SURREBUTTAL TESTIMONY of SEAN WIRTH

The ADSEIR Fails to Address the Substantial Changes in Project Footprint

Staten Island as an example of what using sound barriers would like like.

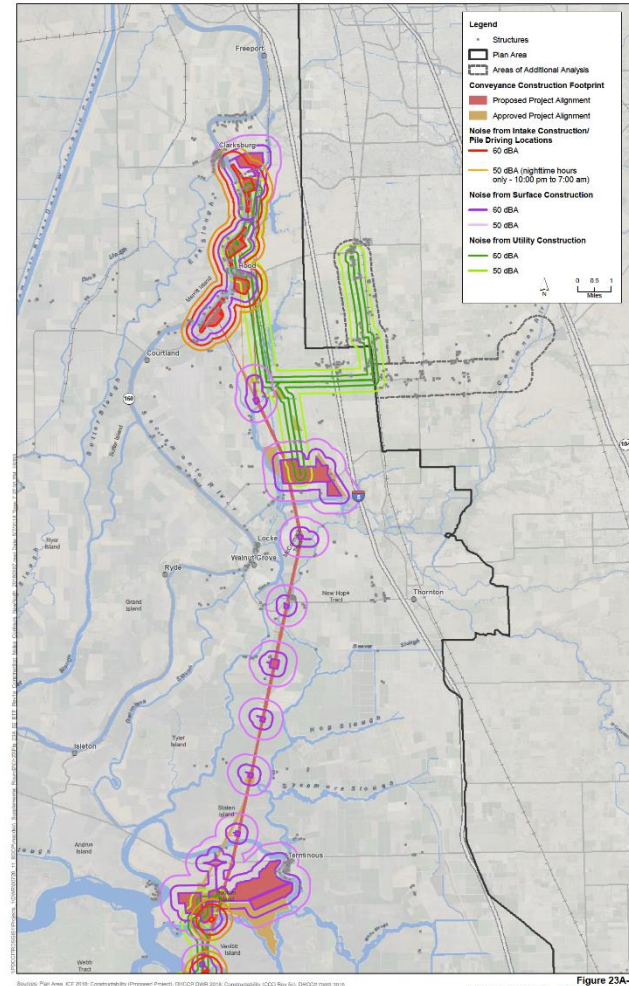
- Staten Island performance standard same as design for conveyance facilities which includes the sound barriers.
